# UNITED STATES PATENT AND TRADEMARK OFFICE

APPLICATION NO.	FILING DATE	FIRST NAMED INVENTOR	ATTORNEY DOCKET NO.	CONFIRMATION NO.
10/701,291	11/04/2003	Bradley S. Berggren	(50035) 60056	5208

<b>Office Action Summary</b>	<b>Application No.</b> 10/701,291	<b>Applicant(s)</b> BERGGREN, BRADLEY S.	
	<b>Examiner</b> Justin M. Larson	<b>Art Unit</b> 3782

**DETAILED ACTION**

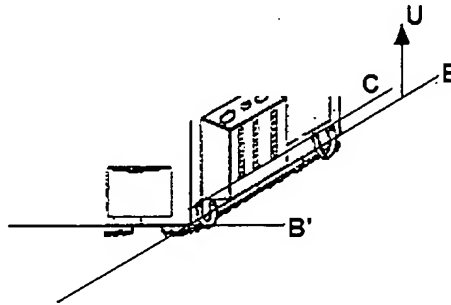
Regarding the front and rear ends being in substantially the same plane, referring to the figure on the left below, the front and rear ends (F, R, below) both clearly exist in precisely the same plane (P).

Regarding the front end portion being dimension and configured for attachment to the center console, the front end (F) of Pesce is of such a size and shape that it is capable of being attached to the center console in a vehicle. Claim 1 recites only functional language implying that the front end is capable of being attached to the center console in a vehicle. Fasteners (52) could be used to secure the front end of Pesce to a center console if one so desired. Structurally, there is nothing stopping one from doing so. There is no language in the claim requiring that the front end be positively attached to the center console of a vehicle.
